REVIEW OF PROPOSED 5th DAM RAISE
UPPER TAILINGS POND EMBANKMENT SYSTEM
LISBON VALLEY OPERATIONS
RIO ALGOM CORPORATION

U.S. Nuclear Regulatory Commission
NMSS

John D. Nelson and Steven R. Abt
Geotechnical Engineering Program
Civil Engineering Department
Colorado State University
Fort Collins, Colorado 80523

October 1, 1980

Fig. 2.2 Critical Embankment Section Analyzed (Source: ref. 3)

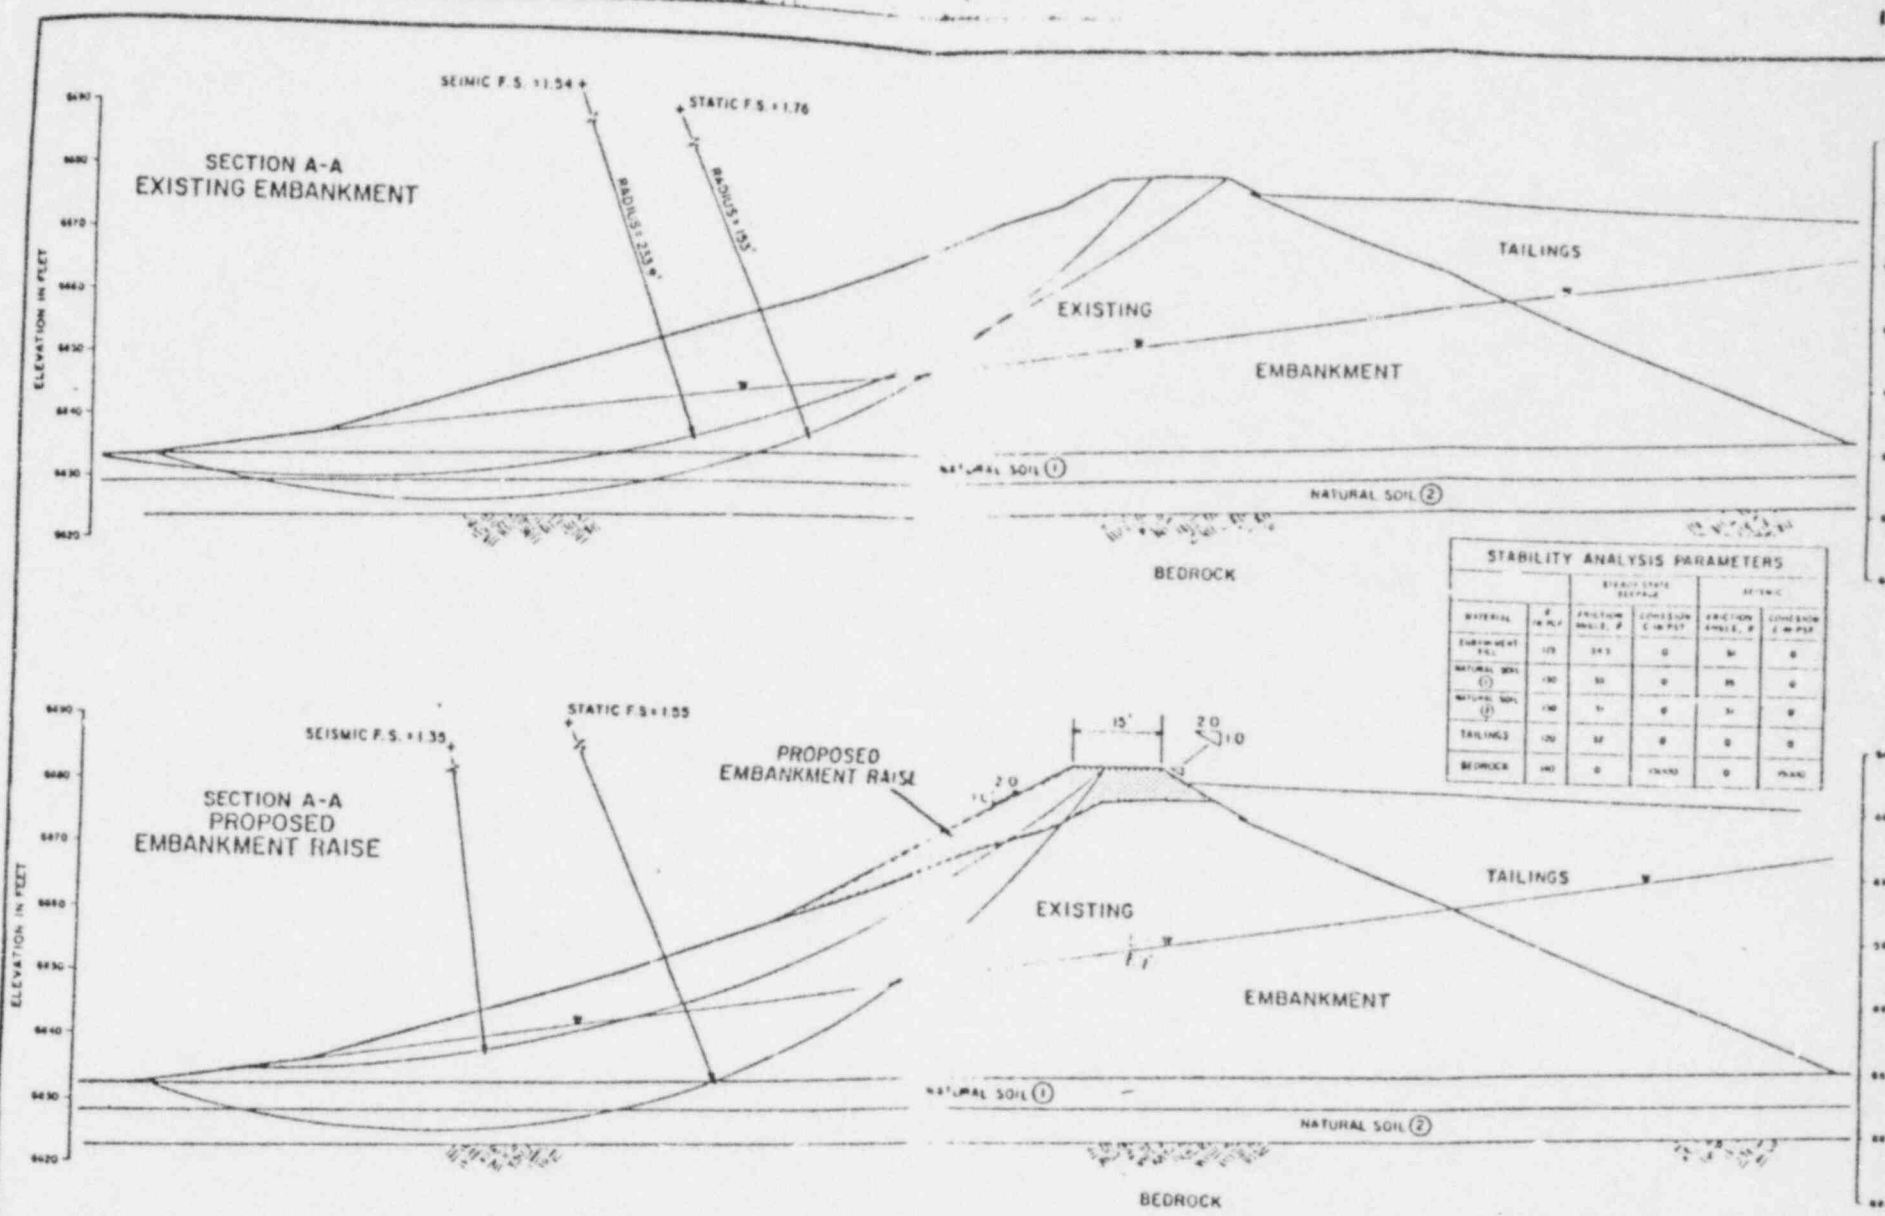
Shear strength values for the natural foundation soils as shown in Figure 2.2 were not substantiated with laboratory data. Furthermore, laboratory test data presented in the Dames and Moore report dated October 2, 1973 (ref. 1) indicate that shear strength values considerably lower than those that were assumed for the stability analyses may exist in the foundation soils. The reviewers, therefore, conclude that inadequate shear strength data for the natural foundation soil has been presented.

The phreatic surface within the embankment that was assumed for purposes of stability analyses is shown in Figure 2.2. However, the boring logs indicate that to the entire depth of soil overlying the bedrock, no groundwater was encountered. Furthermore, piezometers placed at depths of 31.5 feet in boring 1 and 28.5 feet in boring 2 indicated no water at the time reference 3 was prepared. The two piezometers, however, were located near the top of the location of the phreatic surface as shown in Figure 2.2. Consequently, they are not capable of locating a phreatic surface even slightly lower than that. It

4.3 Page 7 of reference 3 indicates that a cutoff trench was excavated and recompacted beneath the embankment. However, the critical embankment section that was analyzed and is reproduced as Figure 2.2 in this report does not indicate that cutoff wall. The effect of that cutoff on the stability analyses should be discussed. Plate 4 in reference 3 (reproduced as Figure 2.2 herein) should be revised to indicate that such a cutoff does exist if it does, or else the text should be revised. Because the inspection report as presented in Appendix B of reference 3 indicates that a cutoff trench was excavated, the reviewers believe that Plate 4 (ref. 3) is incorrect and that the stability analyses should be revised.

4.4 The boring logs and the piezometers indicate that the phreatic surface shown in Plate 4 of ref. 3 (see Fig. 2.2) is incorrect. It is not uncommon for the phreatic surface within an embankment to be lowered by a highly permeable natural foundation soil or through highly permeable bedrock. It was indicated in reference 3 that the upper layers of the sandstone bedrock are weathered and it is possible that the seepage is occurring therein. However, it is also possible that seepage could be occurring through a layer in the natural foundation soils causing a zone of high water content with low strength. It is recommended that adequate sampling in the natural foundation soils should be accomplished to show that such a zone of high moisture content does not exist that

4.2 The basis on which the shear strength of the natural soils was assumed was not presented. The applicant should show by means of laboratory data or field tests that the assumed values of shear strength are in fact accurate. If this can not be demonstrated, revised slope stability analyses should be conducted.

Fig. 2.3 Boring Logs
(Source: ref. 3)

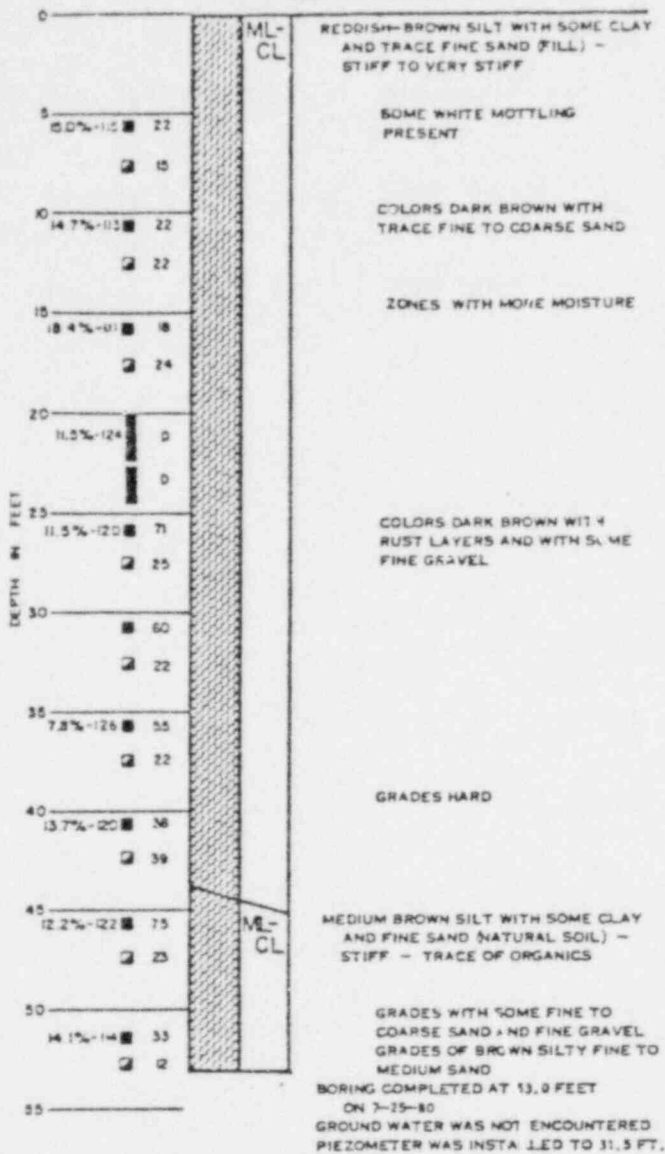
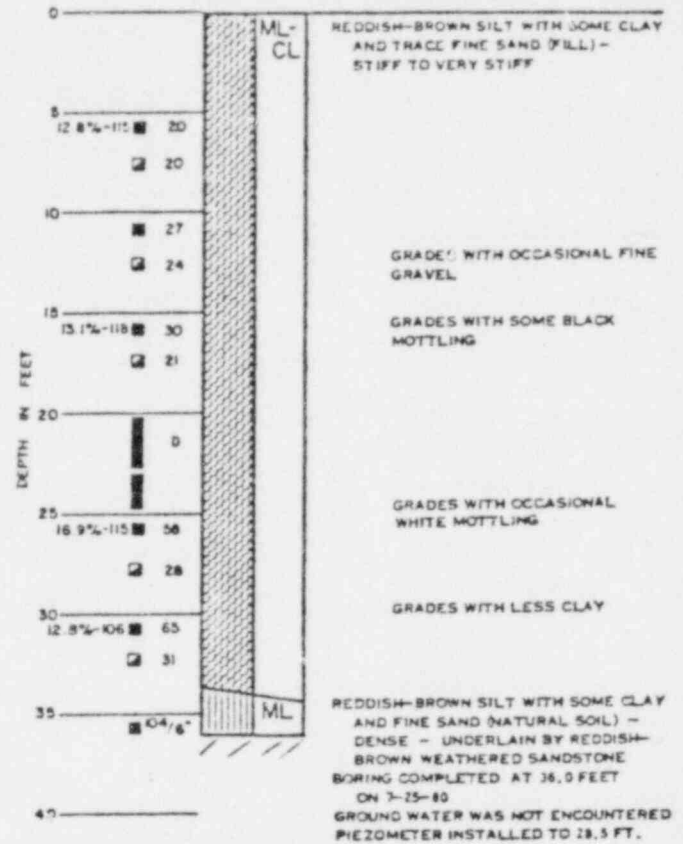
The boring logs that were presented in reference 3 indicated that bedrock had not been encountered in the borings. A subsequent letter from James R. Boddy of Dames and Moore dated September 11, 1980 to Rio Algom (ref. 5) indicates that bedrock was, in fact, encountered. Furthermore, in reference 3 the critical embankment section (as shown in Figure 2.2 of this report) indicates two strata of natural soils. The basis for representing the natural soil in two distinct strata with different shear strengths is not presented and the boring logs do not indicate any basis for doing so. Also, on page 7 of reference 3 it is stated that a cutoff barrier was extended to competent bedrock. This cutoff barrier is not indicated in the critical embankment for stability analyses. It is concluded, therefore, that the critical embankment section as shown in reference 3 (Figure 2.2 of this report) does not represent the actual existing conditions with regard to geometry and shear strength of the foundation soils.

4.1 It is recommended that a revised Appendix A to reference 3 be submitted. This Appendix should include corrected boring logs indicating any variations between the two strata of foundation soils. They should also indicate the depth to bedrock. In addition, this Appendix should include water content and dry density data for the second triaxial test sample.
